**Sizewell C Nuclear Power  
Station (EN010012)**

Correspondence received after submission of the Examining  
Authority's Recommendation Report to the Secretary of State on  
Friday 25 February 2022

The Sizewell-Dunwich Banks. The purple arrows mark 26700N— to the north of which the crest height of Dunwich bank is lowering. Chart base from BEEMS Technical Report TR500 'Sizewell-Dunwich Bank Morphology and Variability'. Page 14. Markup my addition.

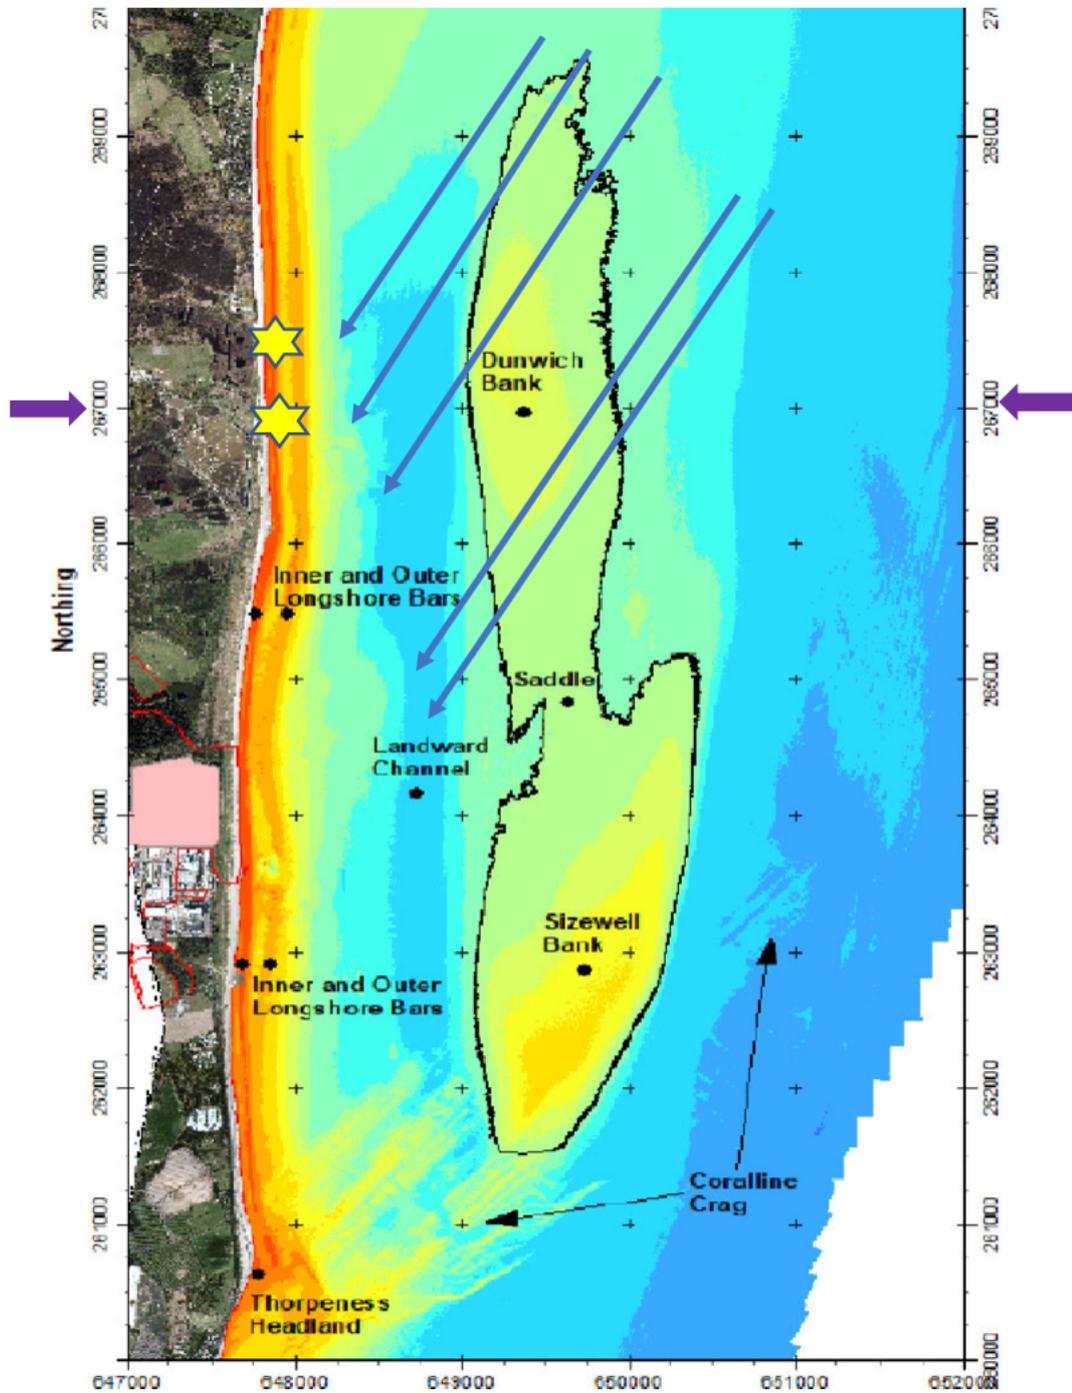
- The orange and red lines show the ‘inner and outer’ nearshore, longshore bars. The DCO provided detailed bathymetry of the inner and outer Longshore bars and not the Sizewell-Dunwich banks.

- The pink square shows the proposed location of Sizewell C.
- **“Records over the last decade show...Dunwich Bank exhibited greater variability in both its morphology and position with erosion north of 267000N, [shown by the purple arrows] resulting in bank lowering of -0.5 to -1.5 m”** DCO: Geomorphology Appendix 20A, op cit., Page 21. BEEMS Technical Report TR500).

- The five blue arrows show the direction of the most significant storm waves from the North/North East— **the largest and longest waves arrive from the N-NE sector. [1:100 wave heights 7.3m-7.8m]**. The driver of sudden and significant erosion on this stretch of coast is from the NNE NE and Easterly directions. The loss of just the northern section of the bank could allow unbroken storm waves to break on the foreshore and increase water volumes in the South Minsmere levels in flood conditions. See map in section 4.3. DCO: Geomorphology Appendix 20A. op.cit., Paragraph 2.3.2.2.2

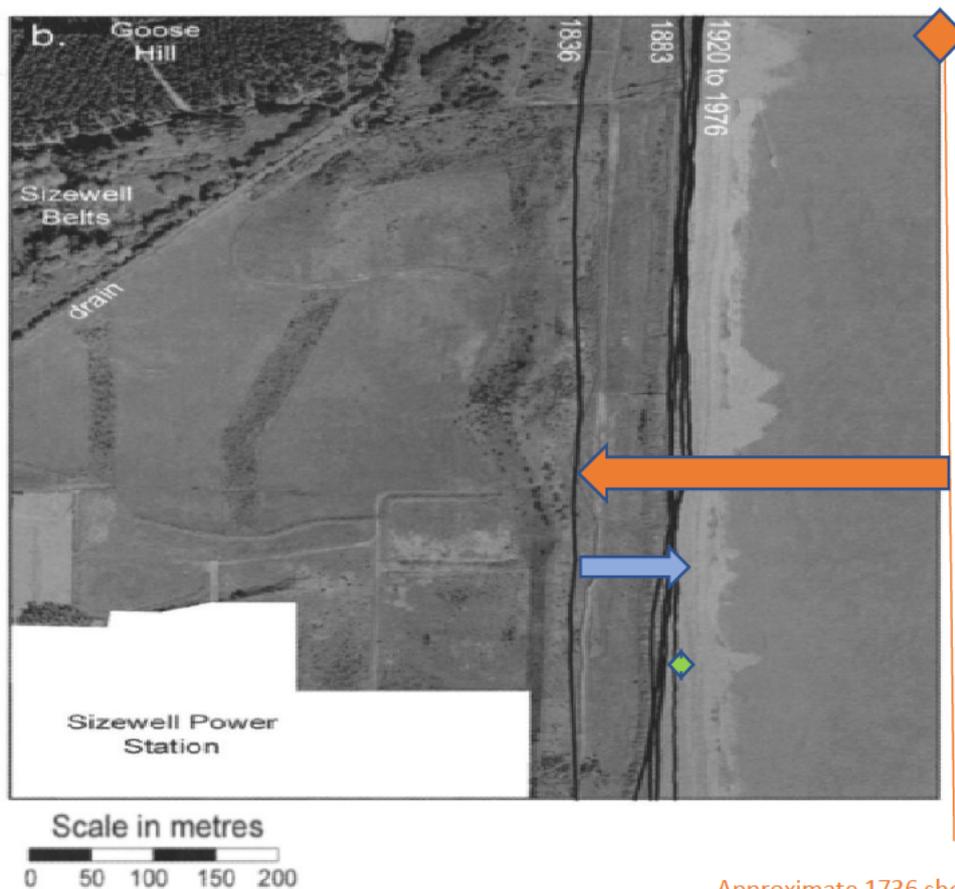
- 1. Erosion:** As stated above, the Sizewell shoreline between 1736 and 1836 is *"the most eroded shoreline in the records"* according to BEEMS TR058 quoting Pye and Blott (2005). It appears that the 1836 shoreline had eroded approximately 300m in one century and was just 20m seaward of the present-day Sizewell B. Orange arrow in the air photo below.
- 2. Accretion: The Sizewell-Dunwich bank grew after 1824 and protected the shoreline;** between 1836 and 1903/1920 the Sizewell shoreline accreted by 83m with sediment from cliffs to the north, particularly Dunwich, to roughly its present location. The present Sizewell shoreline is hence 'soft and erodible'. Blue arrow on the air photo below.

1. **Orange arrow** shows erosion period 1736-1836.
2. **Light blue arrow** shows accretion period post the development of the Sizewell-Dunwich banks, 1836-1920.
3. **Light green double arrow** shows the relative stability period 1920- present.

The Sizewell-Dunwich Banks. The purple arrows mark 26700N— to the north of which the crest height of Dunwich bank is lowering. Chart base from BEEMS Technical Report TR500 'Sizewell-Dunwich Bank Morphology and Variability'. Page 14. Markup my addition.

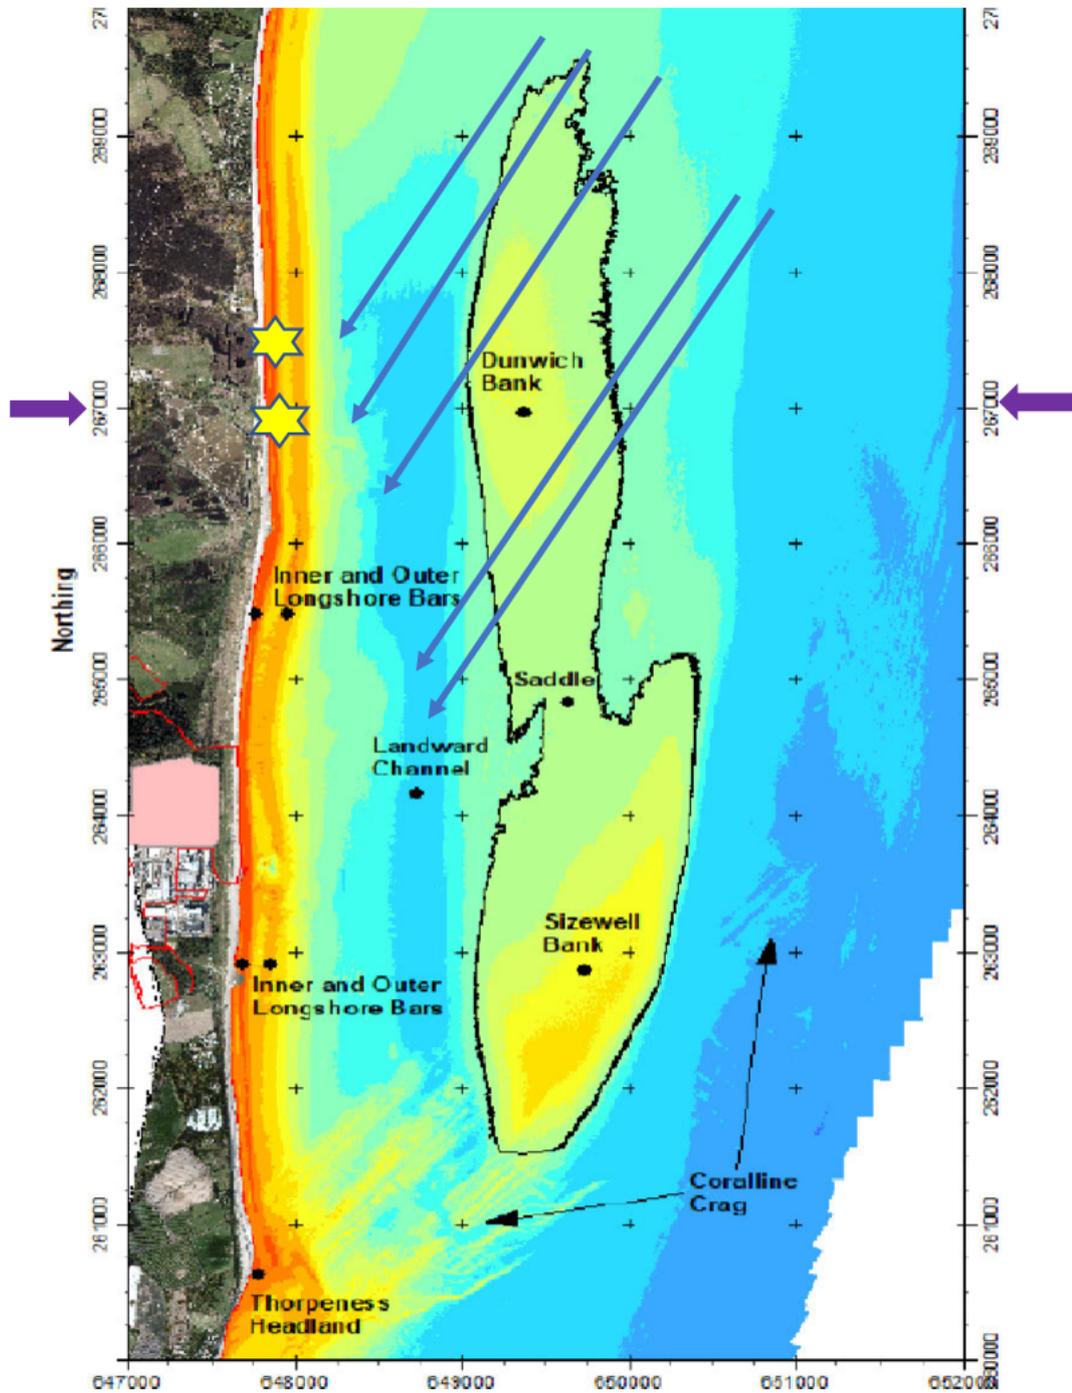
- The orange and red lines show the ‘inner and outer’ nearshore, longshore bars. The DCO provided detailed bathymetry of the inner and outer Longshore bars and not the Sizewell-Dunwich banks.

- The pink square shows the proposed location of Sizewell C.
- **“Records over the last decade show...Dunwich Bank exhibited greater variability in both its morphology and position with erosion north of 267000N, [shown by the purple arrows] resulting in bank lowering of -0.5 to -1.5 m”** DCO: Geomorphology Appendix 20A, op cit., Page 21. BEEMS Technical Report TR500).

- The five blue arrows show the direction of the most significant storm waves from the North/North East— **the largest and longest waves arrive from the N-NE sector. [1:100 wave heights 7.3m-7.8m]**. The driver of sudden and significant erosion on this stretch of coast is from the NNE NE and Easterly directions. The loss of just the northern section of the bank could allow unbroken storm waves to break on the foreshore and increase water volumes in the South Minsmere levels in flood conditions. See map in section 4.3. DCO: Geomorphology Appendix 20A. op.cit., Paragraph 2.3.2.2.2

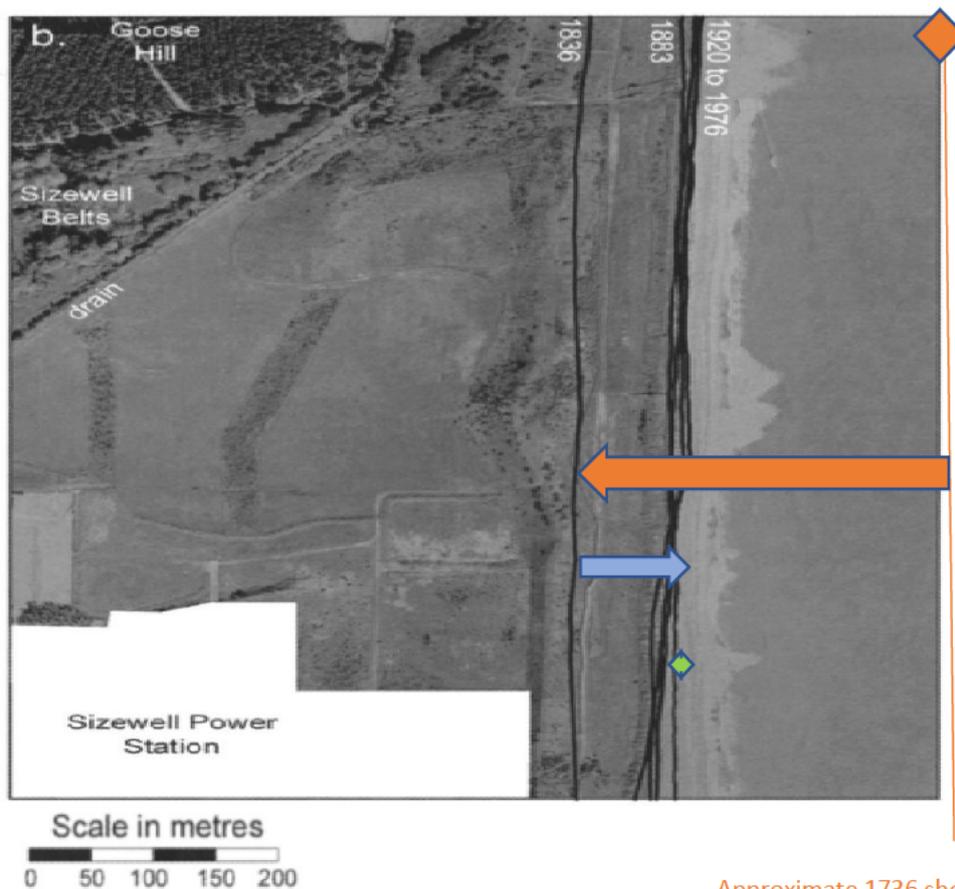
- 1. Erosion:** As stated above, the Sizewell shoreline between 1736 and 1836 is *"the most eroded shoreline in the records"* according to BEEMS TR058 quoting Pye and Blott (2005). It appears that the 1836 shoreline had eroded approximately 300m in one century and was just 20m seaward of the present-day Sizewell B. Orange arrow in the air photo below.
- 2. Accretion: The Sizewell-Dunwich bank grew after 1824 and protected the shoreline;** between 1836 and 1903/1920 the Sizewell shoreline accreted by 83m with sediment from cliffs to the north, particularly Dunwich, to roughly its present location. The present Sizewell shoreline is hence 'soft and erodible'. Blue arrow on the air photo below.

1. **Orange arrow** shows erosion period 1736-1836.
2. **Light blue arrow** shows accretion period post the development of the Sizewell-Dunwich banks, 1836-1920.
3. **Light green double arrow** shows the relative stability period 1920- present.

Figure 3-6 - SZB Interface - Plan

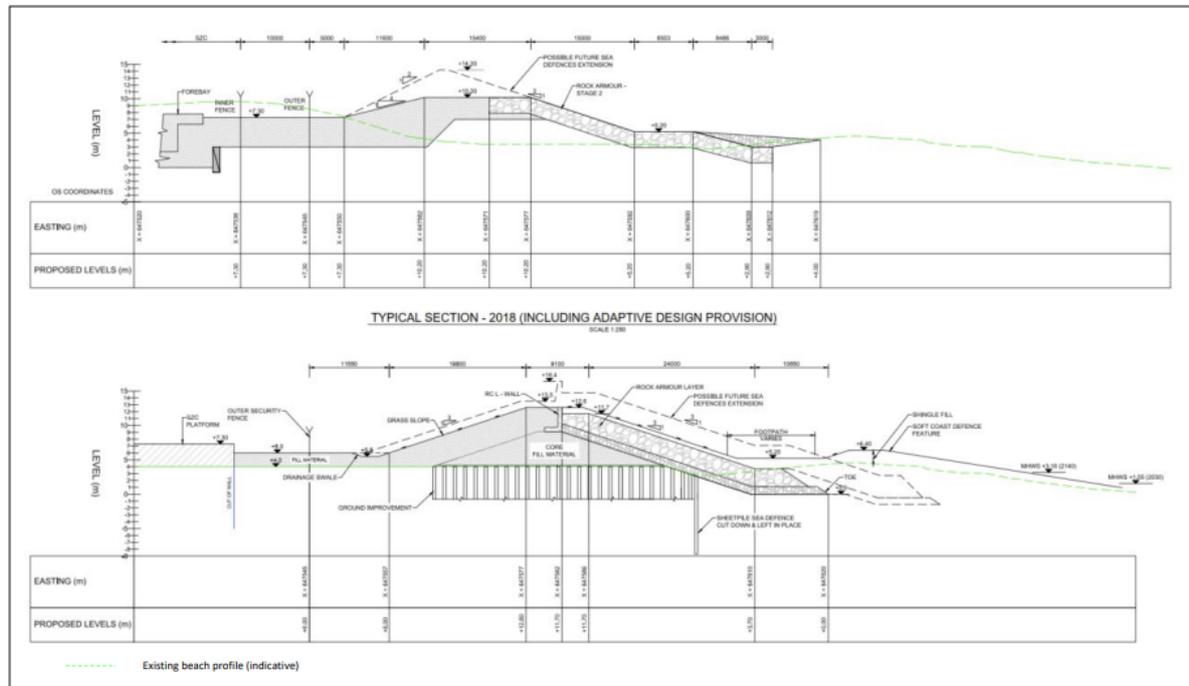
In the Sizewell C Coastal Defences Design Report ([REP2-116](#)) Appendix A, Figure 3-12, a cross-section of the HCDF and SCDF is shown for a roughly central position along the SZC frontage and reproduced below. Unfortunately, this does not show the southern roundhead cross-section which will have a steeper SCDF slope and will also protrude further eastward as shown below in Figure 3.6 Sizewell B Interface Plan.

Allowing 3m for the rise to 6.2m, 3m for the flat top of the new SCDF, at a 1 in 5 slope a further ~32m of SCDF will be required to reach 0m OD.
